# CITY OF ALBUQUERQUE

June 19, 2017

**RE: McMahon Market Place Lots 9C&D**  
**Grading and Drainage Plan**  
**Stamp Date: 6/13/17**  
**Hydrology File: A11D011F**

SHEET NO:  
C-1

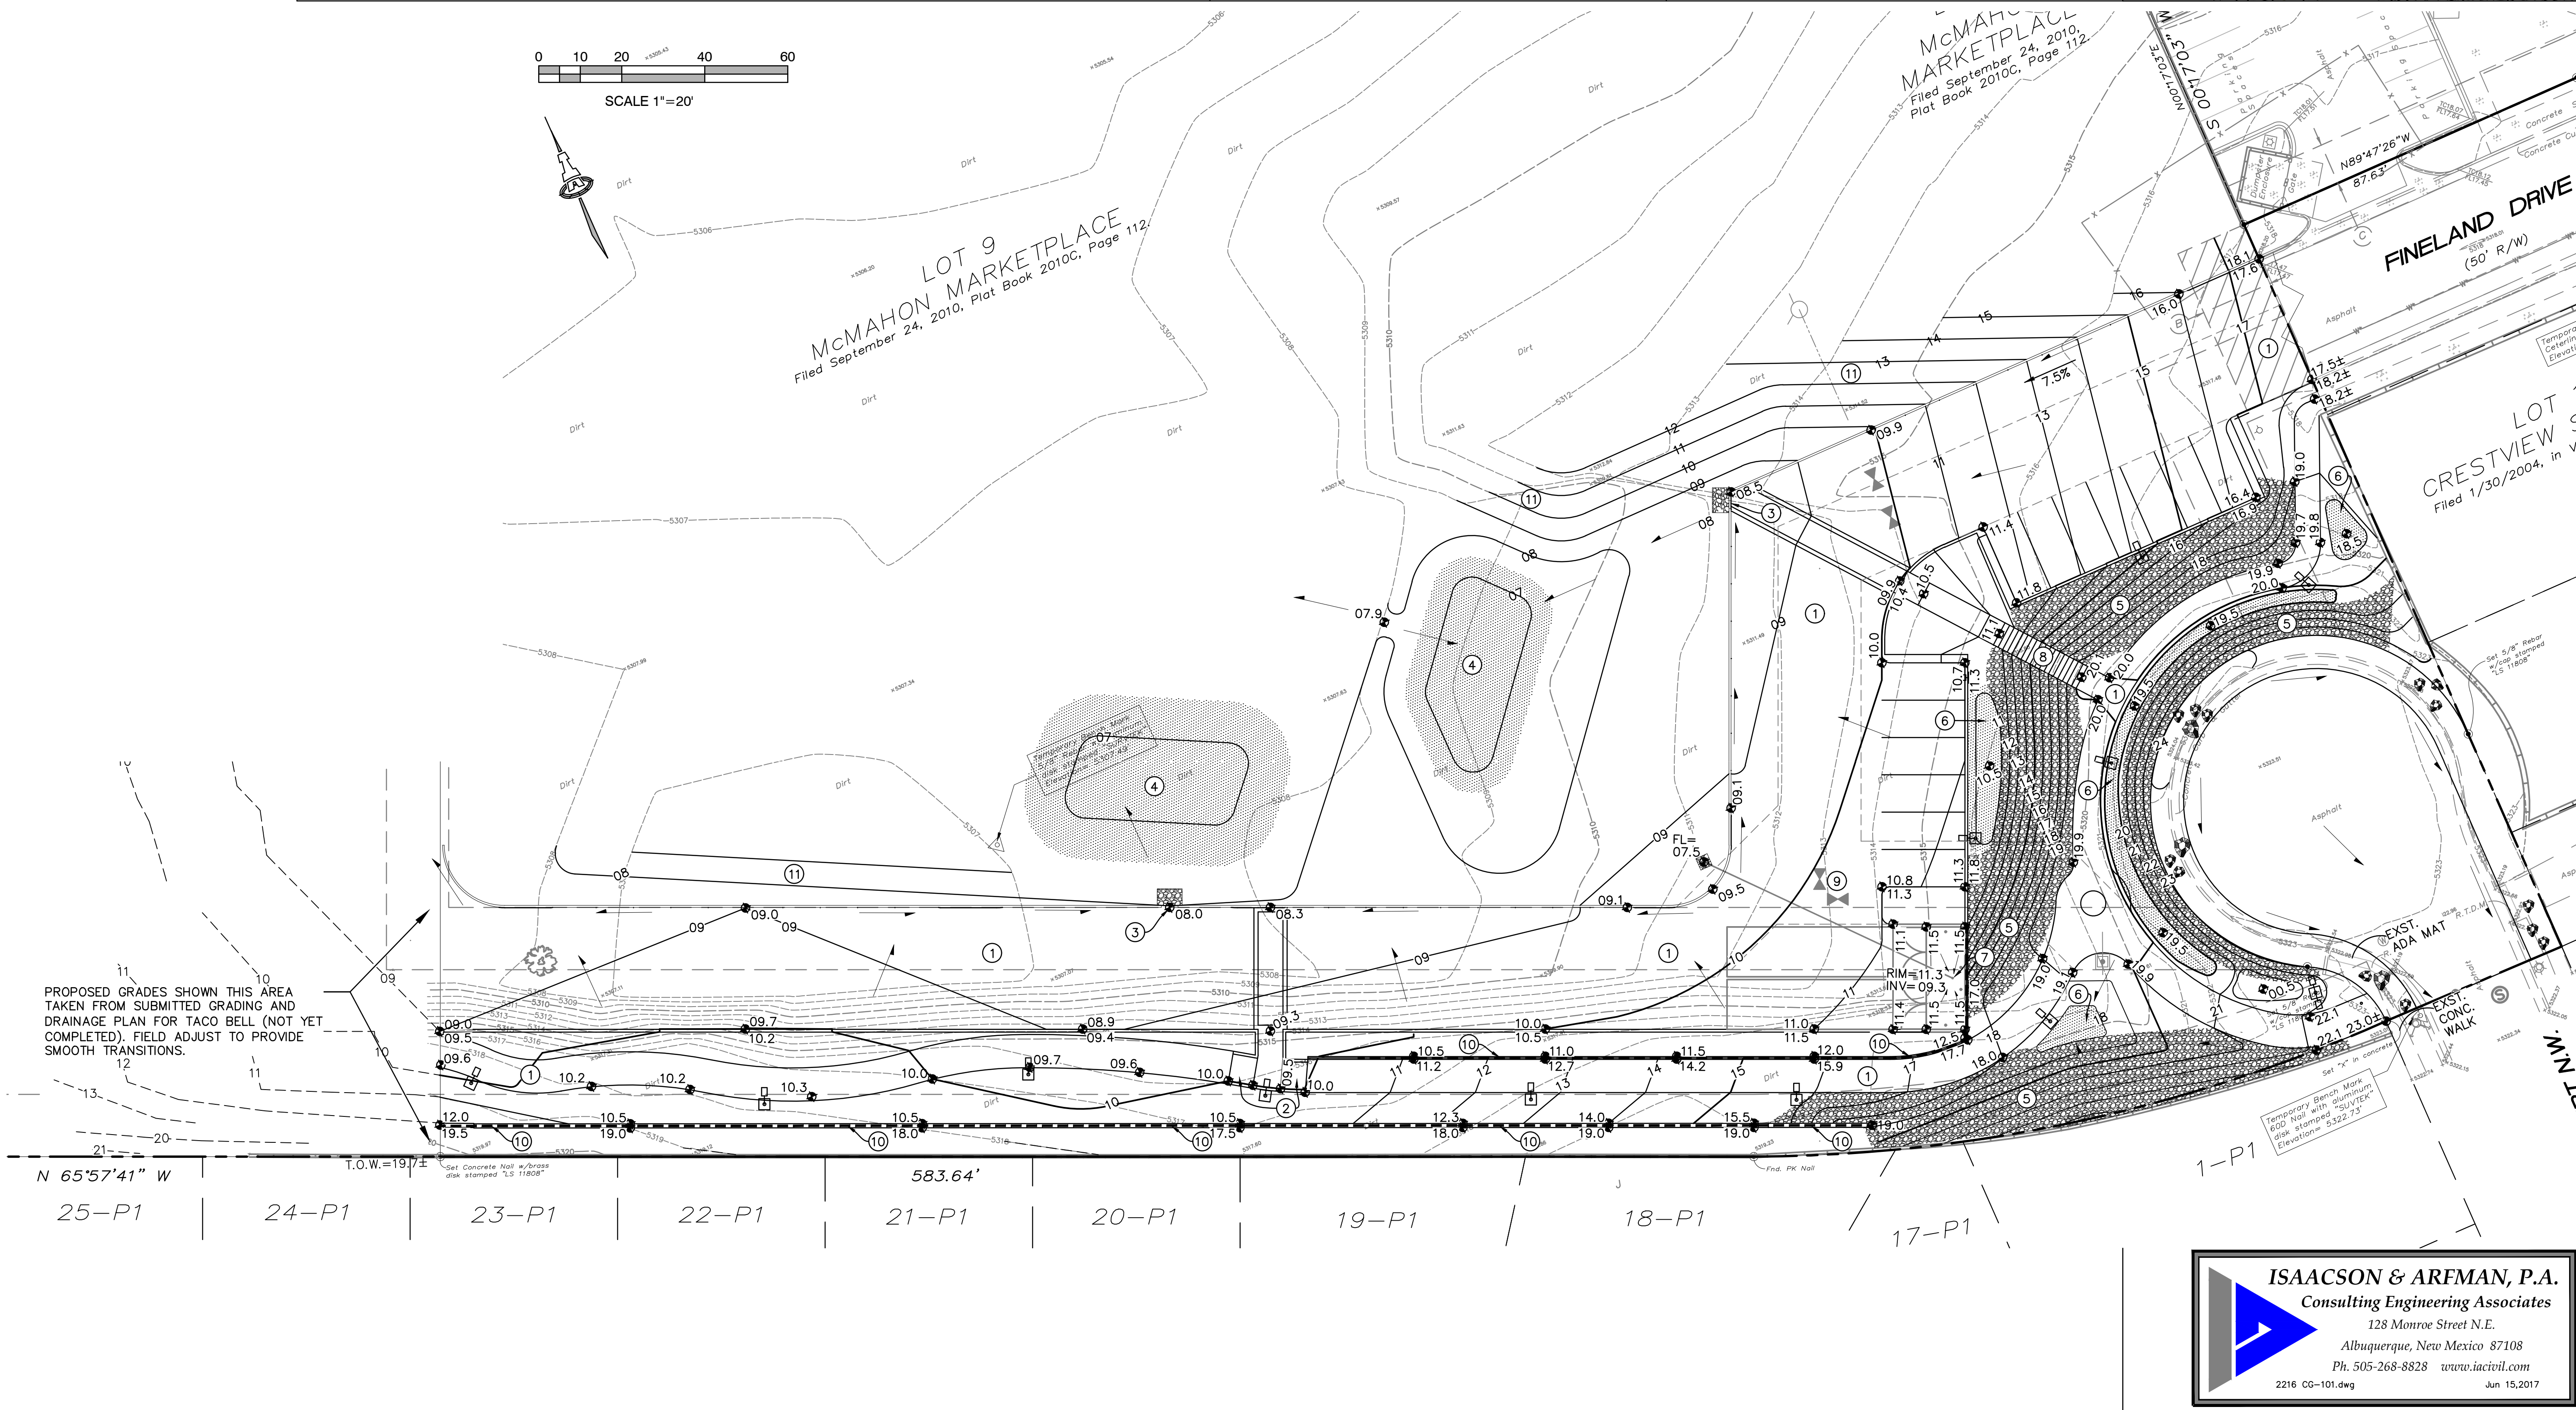
2. On Sheet C-1. On the Vicinity Map, please show the site area from the Taco Bell site to Fineland Drive.
3. On Sheet C-1. Please show the existing Taco Bell development, about 25 feet min. into the site. Please show the existing retaining wall with top of wall and bottom spot elev., existing sidewalk, curb, and hatch the existing pavement.

4. On Sheet C-1. Please provide a cross section of the retaining wall. This section should include the existing block wall along the property line, the proposed drive, and the proposed grades on the other side of the drive.

5. On Sheet C-1. It appears that the proposed retaining wall is taller than 8 feet high in a spot. The maximum height for a retaining wall is 8 feet without an approved variance. This can be handled with changing the spot elevation at the bottom of the wall so it does not go past the 8 feet height maximum. Please clarify.

6. On Sheet C-1. At both of the proposed curb cuts, there appears to be patch of rip rap or gravel. If so, then please label it and give an area for them.
7. On Sheet C-2. Please label both of the basins in the Drainage Basin Map.
8. On Sheet C-2. Please enlarge both basins' ponding charts so that it is legible. These also should be placed adjacent to the Basin Map.
9. On Sheet C-2. Please show the basins' calculations for the 100 year 6 hour storm along with the overall development calculations which you provided.
